DOCUMENT 00 90 00
ADDENDUM

ADDENDUM NO. [1] **Date: November 23, 2021**

RE: SCHOOL DISTRICT OF LA CROSSE
CENTRAL HS HVAC UPGRADES
1801 LOSEY BLVD SOUTH
LA CROSSE, WI 54601
HSR PROJECT NO. 21035

2 FIRST FLOOR - POWER
1/8" = 1'-0"

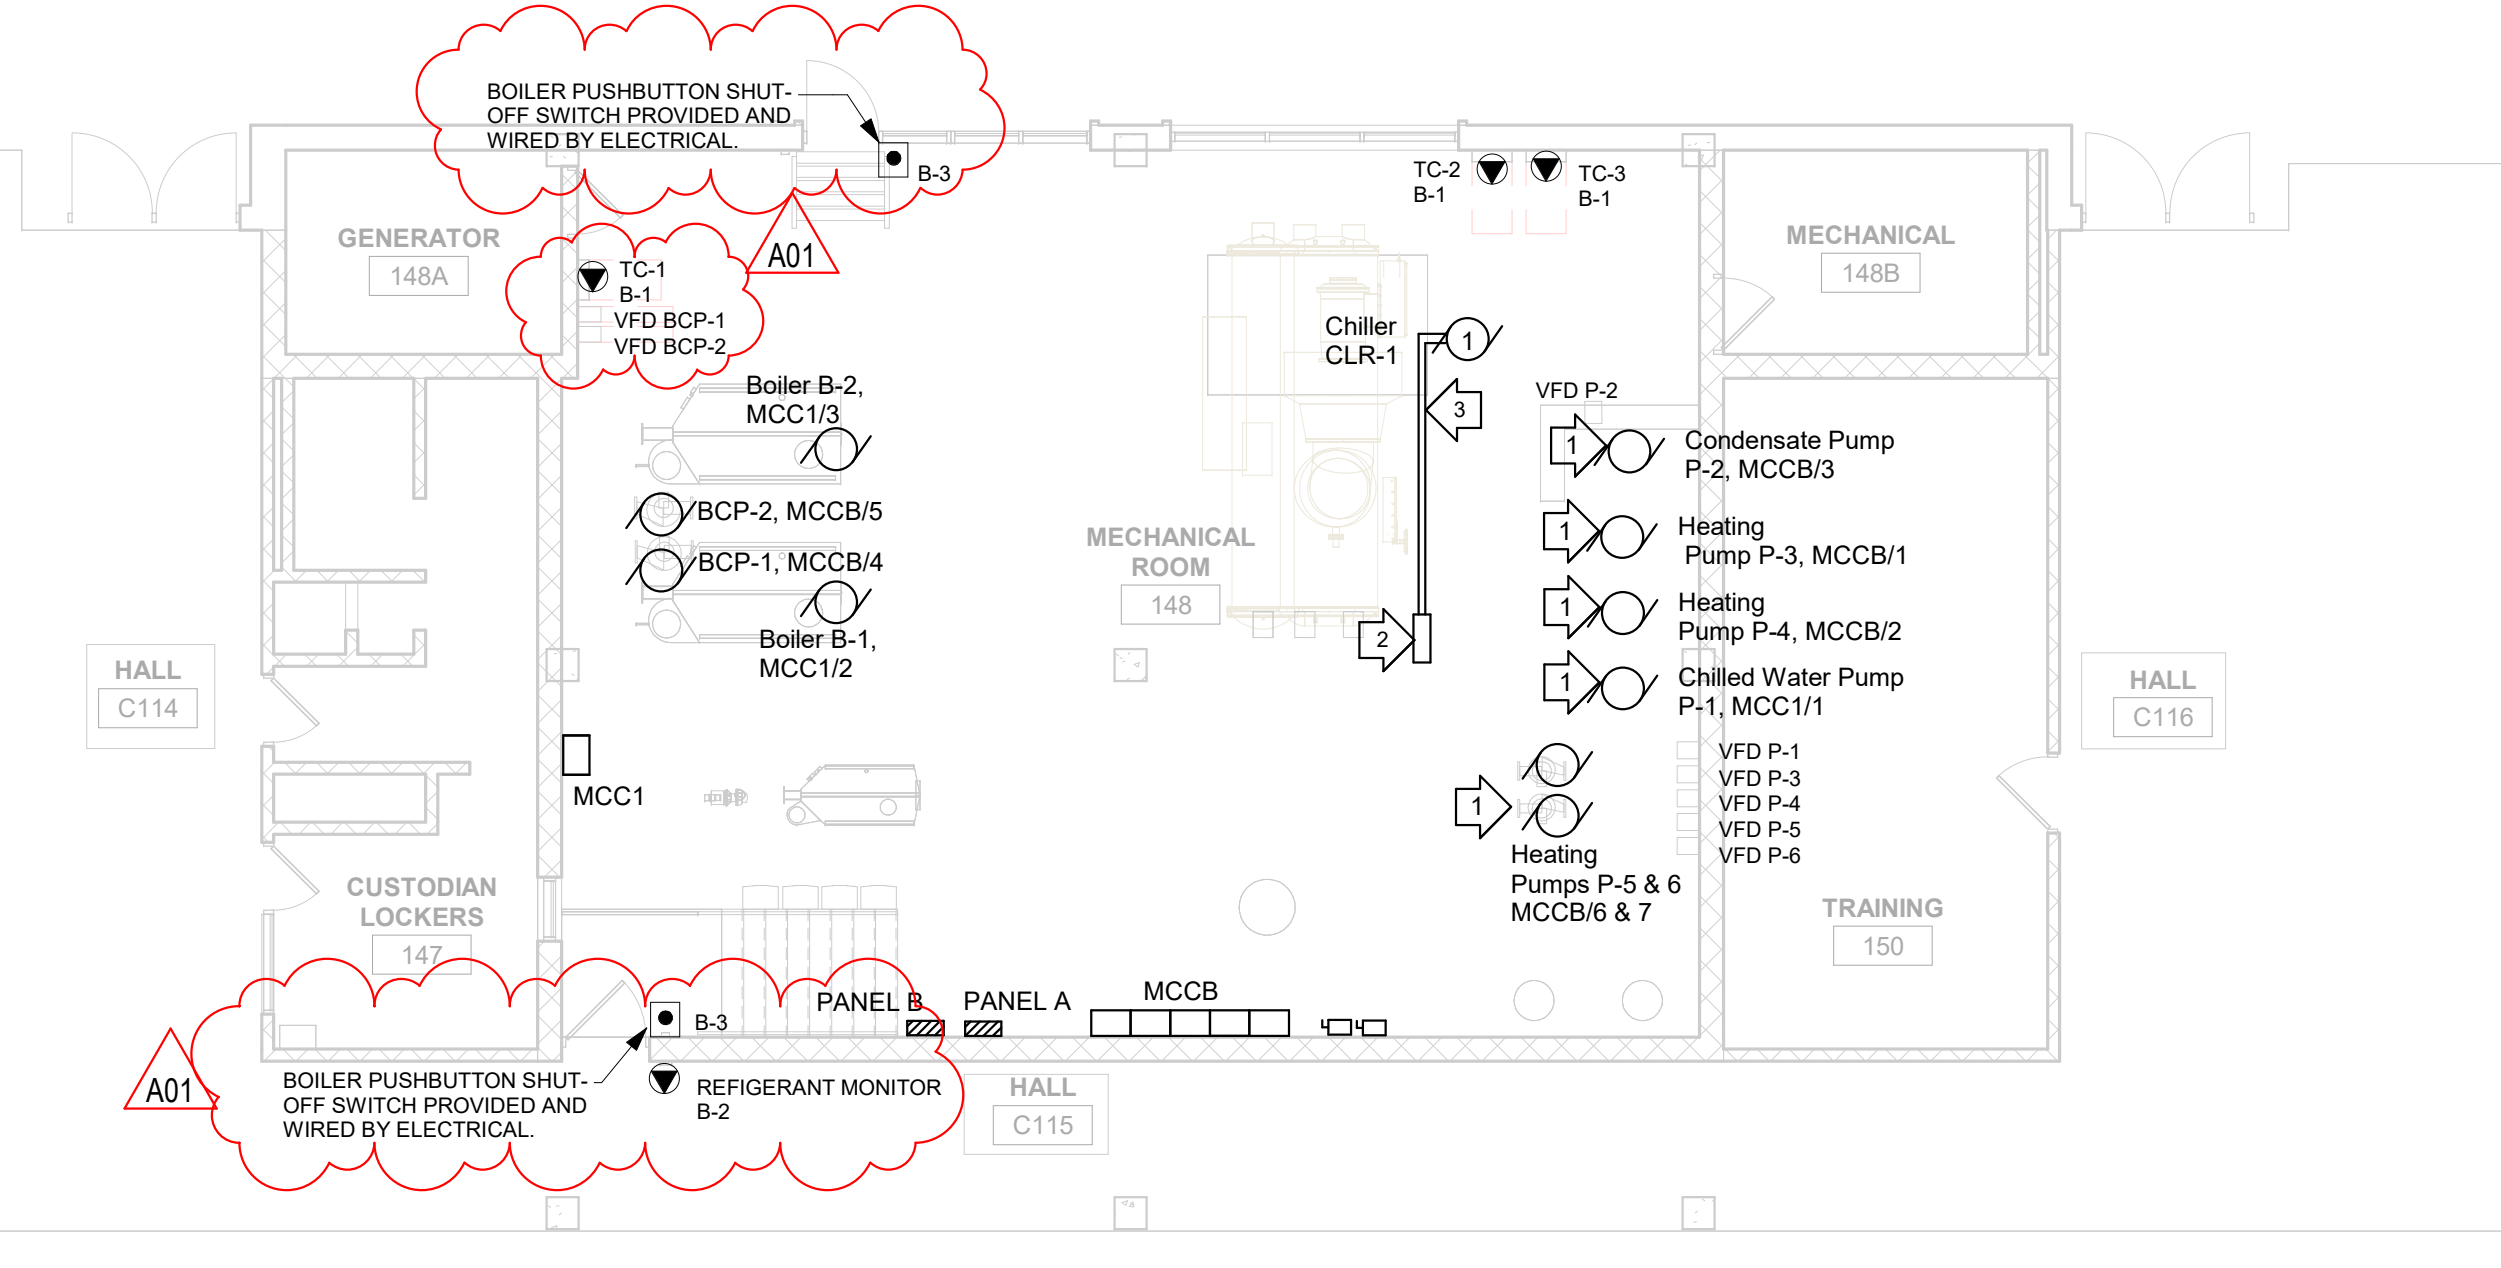
- a. Plan 2/E100:
 - 1) Added Boiler emergency shut off switch.
 - 2) Added electrical connection to refrigerant monitoring panel.
 - 3) Identified location of BCP-1 & 2; VFD locations.
- b. Motor Schedule:
 - 1) Added motor starters (FVNR) starters for: P-7, 8, 9 and 10.
 - 2) Revised HVAC Equipment identifications.
 - 3) Revised starter column text.
 - 4) Revised motor schedule remarks.
- c. Motor Control Center Schedule MCCB:
 - 1) Revised starter sizes.
 - 2) Revised fusible switches.
 - 3) Revised remarks.
- d. Panelboard Schedule:
 - 1) Added circuit breakers.

4 Floor Plan Fan Room Removal
NTS

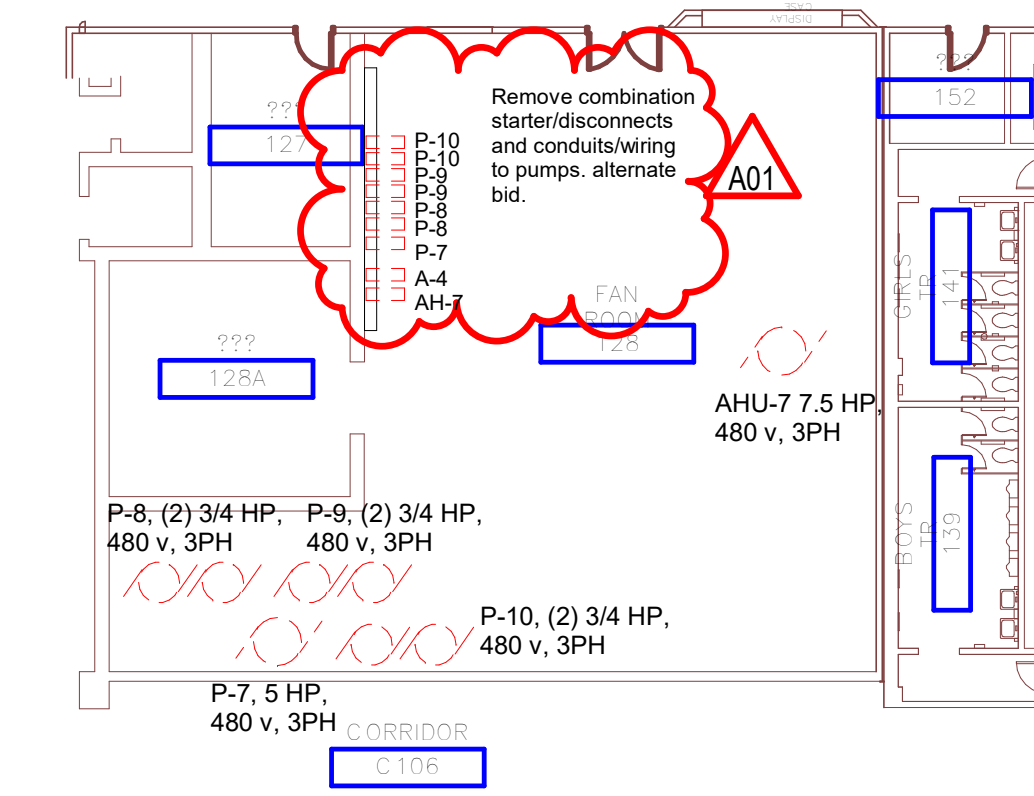
- a. Plan 4/E101:
 - 1) Indicated removal of Pump and air handler combination starter/disconnects.
- b. Plan 5/E101:
 - 1) Indicated locations of disconnects and starters for new motors and VFD units.
- c. Specific Notes: Sheet E101:
 - 1) Added notes 3. 4. and 5.
